MEMORANDUM

RE: Bedrock Monitoring Well Placement Amendment Review Request to the Technical Review for the RAB of the "Draft Site Specific Sampling and Analysis Plan Remedial Investigation, Part 1, at Acid Area 1" by Jacobs Engineering

DATE: June 12, 2007

FROM
Shaw
2004 GROUNDWATER DATA SUMMARY
AND EVALUATION REPORT
FORMER PLUM BROOK ORDNANCE WORKS
NASA PLUM BROOK STATION
SANDUSKY, OHIO
FIGURE 6-5
DELAWARE LIMESTONE GROUNDWATER
ELEVATION CONTOUR MAP (AUGUST 2004)
AREA
JOB NO
DRAWING NO
REV
SITEWIDE
843856
843856_DELDGN

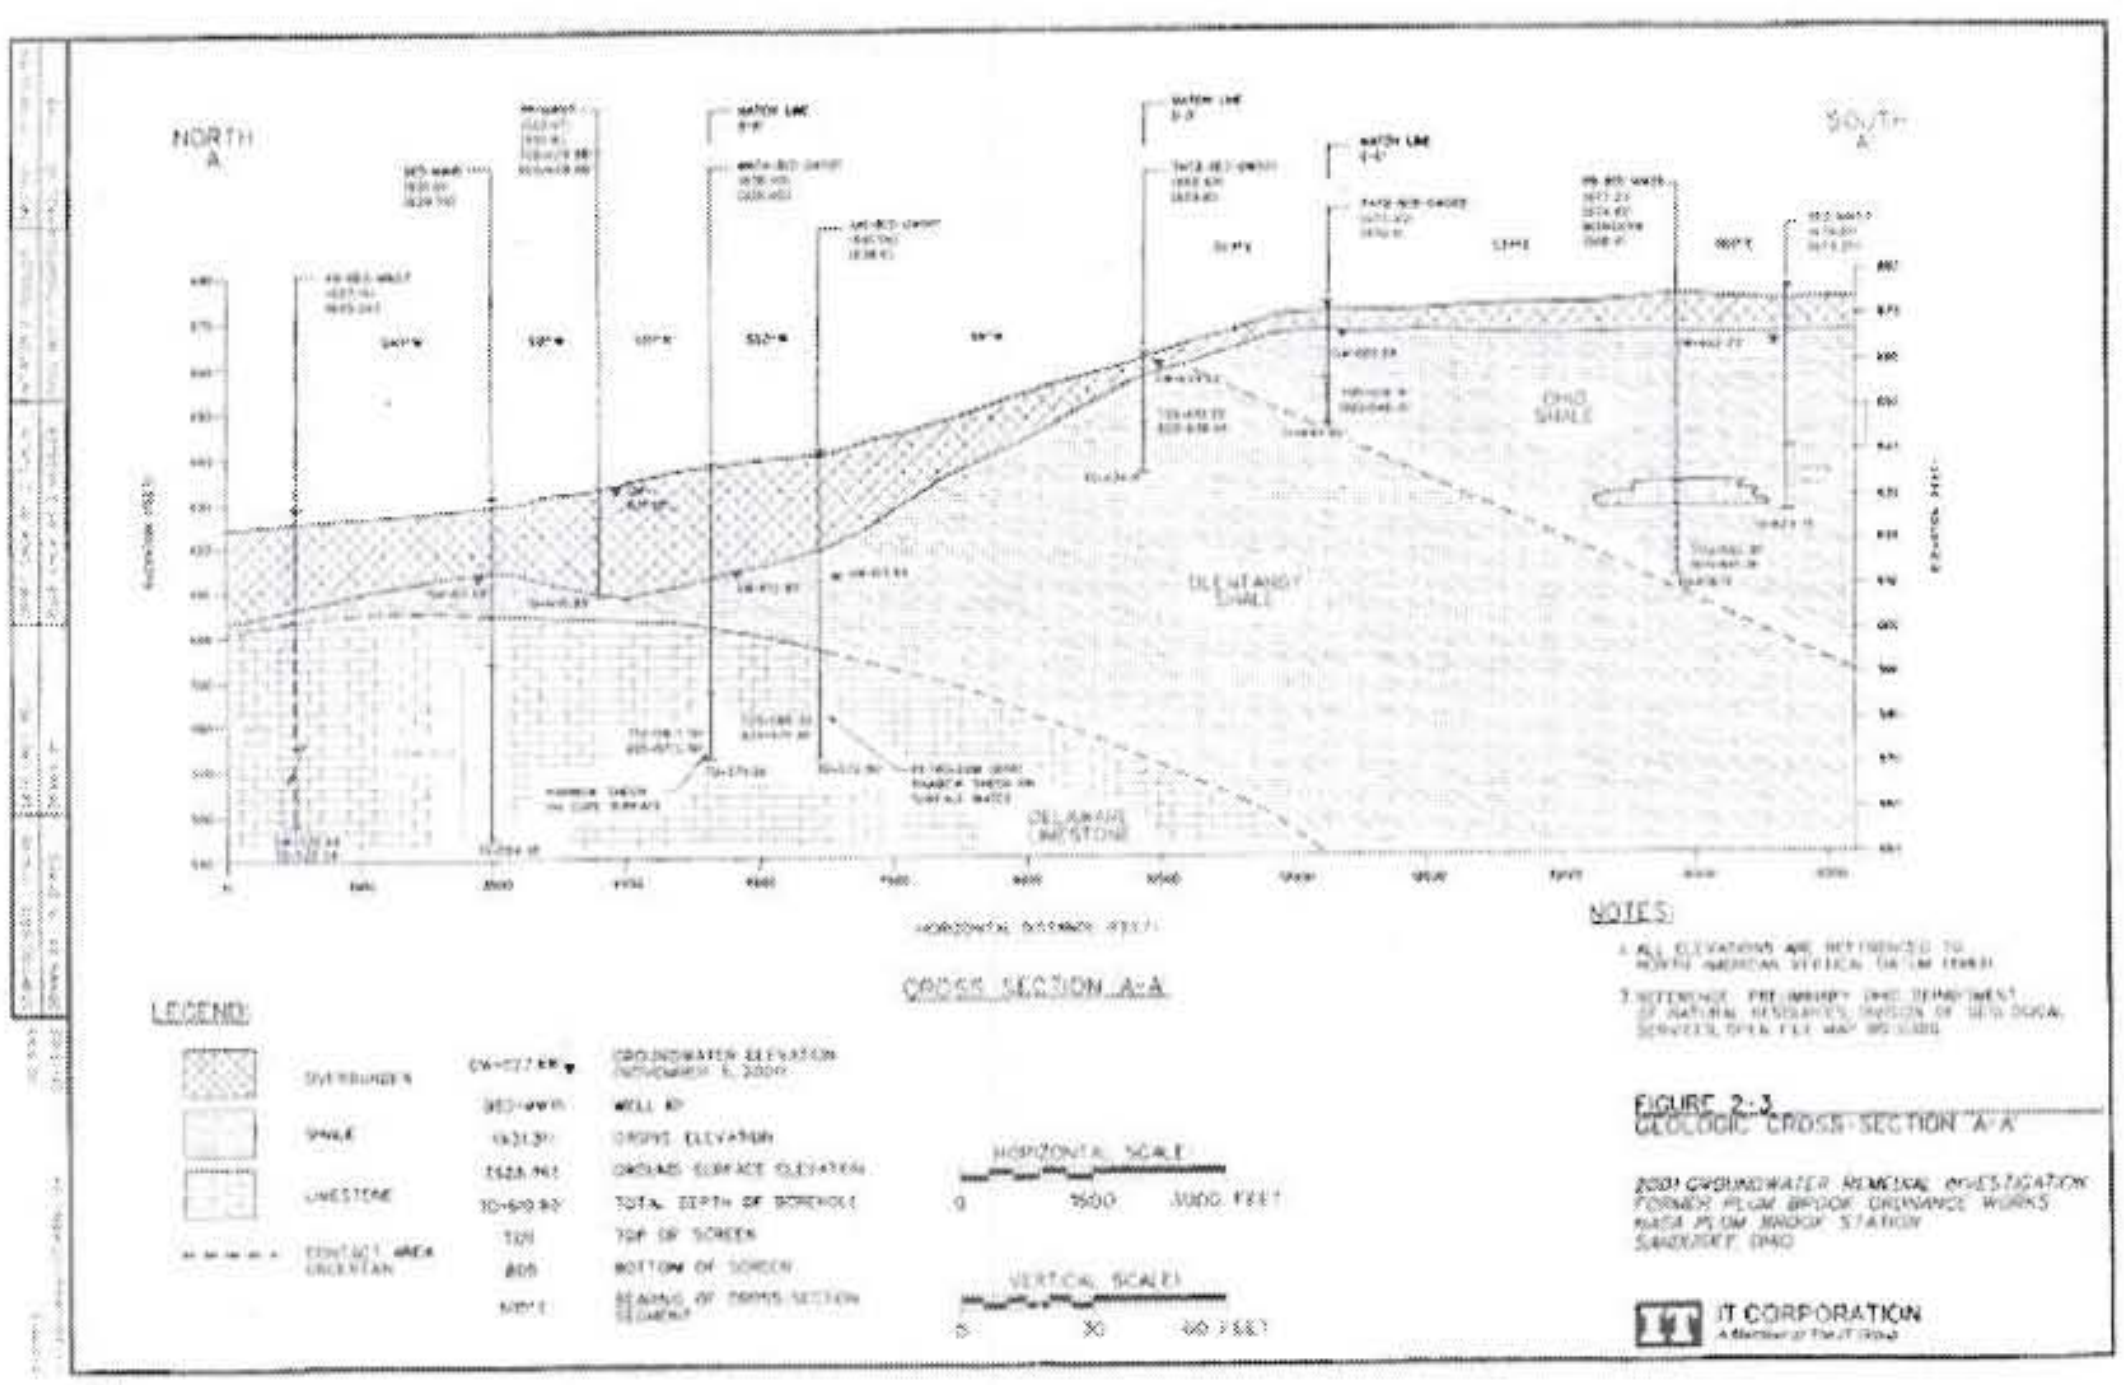
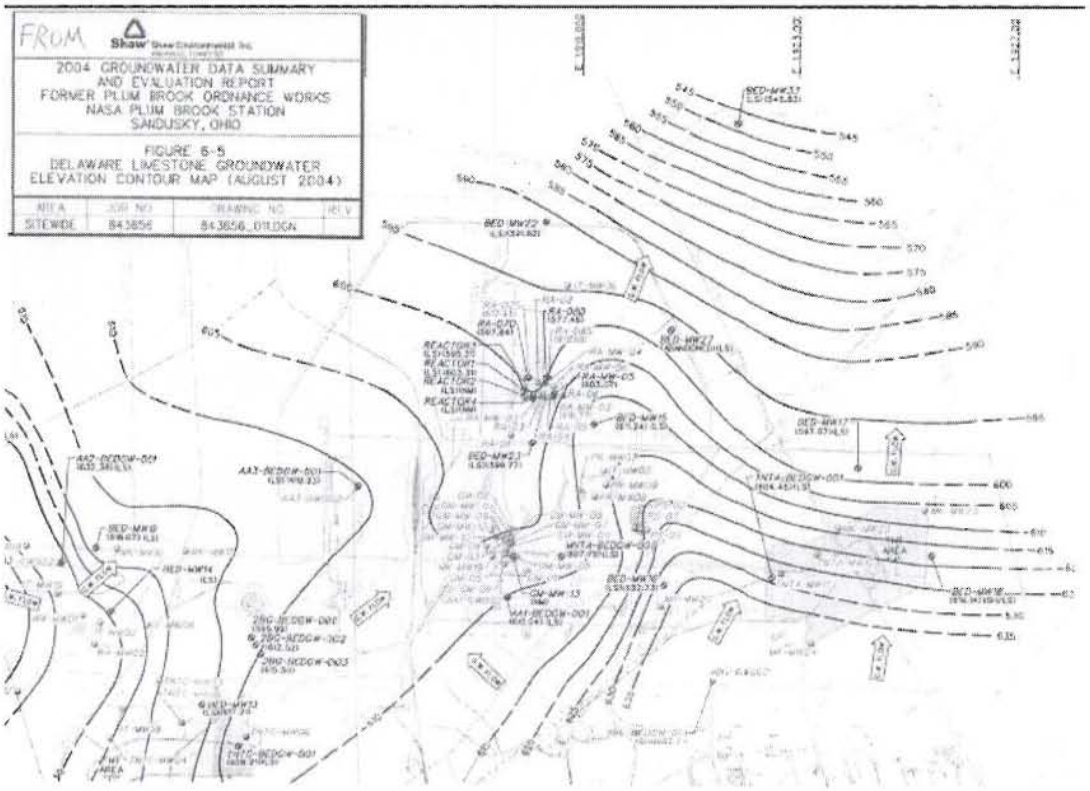
Review from Figure 6-5, Delaware Limestone Groundwater Elevation Contour Map (August 2004)

Typically in this part of Ohio, unless ground water levels are being stressed by ground water withdrawals for public water supplies and/or dewatering, static water levels closely mirror the flat surface topography. Once Lake Erie is reached (here Sandusky Bay), the lake level becomes the same as the ground water level and as you move out into the lake, the land level falls beneath the level of the lake. That is not the picture that is presented in this Figure 6-5. While the land surface is relatively flat, for instance, the drop in surface elevation from BED-MW16 (633.36' amsl) to BED-MW33 (619.87' amsl) is only 13.49' drop in elevation; the ground water drop is from 632.73 at BED-MW19 to 545.83' amsl at BED-MW33 for a drop of 86.9' over the same distance. According to the Erie County Soil Survey GIS map, the distance between BED-MW16 and BED-MW33 is about 8,500' for a ground water gradient of just over 0.01 or ~1:100. A gradient of 0.0018 or ~1:560 would have been more typical for this area. In fact, the static water level at BED-MW33 is on the order of 25 feet below the level of Lake Erie. Assuming that there is no physical problem with the construction of the well that static water level reading cannot physically happen unless there is a pumping source some point to the northeast beyond BED-MW33 that is exerting its influence as far south as BED-MW16. The southeast corner sump of the Wagner Quarry is about 3,500' beyond BED-MW33. The direction of ground water lowering is determined by placing a perpendicular line across the ground water contours. Such an arrow is shown near well IT-MW06. There the direction of ground water flow is projected to be to the northeast.

In fact, with the exception of the flat area to the southwest of the NASA Reactor, almost the entire portion of the site shown in the Figure 6-5 that was supplied to me is demonstrating significant static water lowering to the northeast. The corner of Acid Area 2 that is shown on this abbreviated version of what probably is a lager figure, shows a reversal in ground water flow to the southwest in the area of AA2-BEDGW-001. In addition, there are several locations where contour lines are drawn through water levels which do not support the placement of the lines.

2. Why is there at 86.9 foot drop between BED-MW16 and BED-MW33?
3. Why is the static water level reported in BED-MW33 approximately 25' below Lake Erie?

4. Does this Groundwater Elevation Contour Map (August 2004) generate information that supports a connection to the dewatering sump in the southeast corner of the Wagner Quarry? If not, why not? What other explanation can be developed for the significant changes in the ground water gradient over the site, especially to the north of the site?

5. The 630 contour is placed next to TNTA-BEDGW-001 but the Static Water level reading for that well is 604.45? Why did this happen?
6. By the time that this map is generated, BED-MW27, another "stinky" but also contaminated well on the northern perimeter of the site has been abandoned. The Abandoned well sits between the 600 and 595 foot contours. However, the static water levels for this well were never measured at higher than 582.54' amsl during the first measurement, falling to 573.69' amsl at its last reading. These historic lower water levels were not considered when the August 2004 map was drawn. Why?

7. There are a series of limestone bedrock monitoring wells surrounding the NASA Reactor. The 600' contour line is drawn though this group of points. However, the ground water elevations range from a high of 603.31' amsl at REACTOR 1 to a low of 577.46' amsl at RA-08D on the same contour. In addition, BED-MW23, which is considerably south of the NASA Reactor measures 599.77' amsl. Why was this contour constructed in this manner disregarding the two anomalous readings? Could the contours have been constructed in another way to honor the disregarded water level elevations at RA-08D and BED-MW23?

8. Could there be a relationship between the low levels at 2BG-BEDGW-001, BED-MW23, RA-08D, the abandoned BED-MW27, and BED-MW33 which seem to bisect the site? Where does the base of the "dry well" at Acid Area 3 fall into this set of "low" elevations? The static water level at 2BG-BEDGW-001 is still approximately 136 feet higher than the sump at the Wagner Quarry.

9. There are a group of three wells at the No. 2 Burning Grounds. They range in elevations between 615.50' amsl for 2BG-BEDGW-003 to 595.99' amsl for 2BG-BEDGW-001. The 610' contour is drawn through the set with the 615.50' amsl well down gradient of the 610 foot contour and the 595.99' amsl well up gradient of the 610 foot contour. Why did that happen?

10. If the contours were redrawn to better honor the static water level elevations in all of the measured wells, would that alter the "flat area between TNTC-BEDGW-001 (608.21' amsl) and the NASA Reactor high reading of 603.31' amsl measured at REACTOR 1.

11. This section of the site, referred to as the "groundwater trough" by Jacobs and Shaw has a drop of only 4.9 feet between these two monitoring wells. It is the flattest portion of the site, given the current contour arrangement. Why is it called the "groundwater trough"?

12. Ohio Department of Natural Resources Div. of Water tells us that the regional ground water flow is basically in a northern direction to Lake Erie? Why is there a ground water reversal in Acid Area 2, showing ground water flow to the southwest? What mechanism, either on-site or off-site is controlling this static

ground water dip to the southwest? Has any source been identified? Has any source been looked for? Are there data points beyond the portion of the map that I have that establishes a continuing downward trend?

While there may well be logical answers and/or explanations for the questions I have raised, those answers and/or explanations are not clearly contained in the information that is provided to me. Instead, my review of the August 2004 Groundwater Elevation Contour Map indicates a sharp downward gradient from the area of BED-MW16 to the north-northeast the the Wagner Quarry sump. In addition, there seems to be some control exerted by the NASA Reactor sump but its actual impact is not easily observed because of the number of data points that are not honored by the contour lines. At a minimum, this static ground water map of August 2004 does not have the appearance of a site that exists under natural static water conditions.
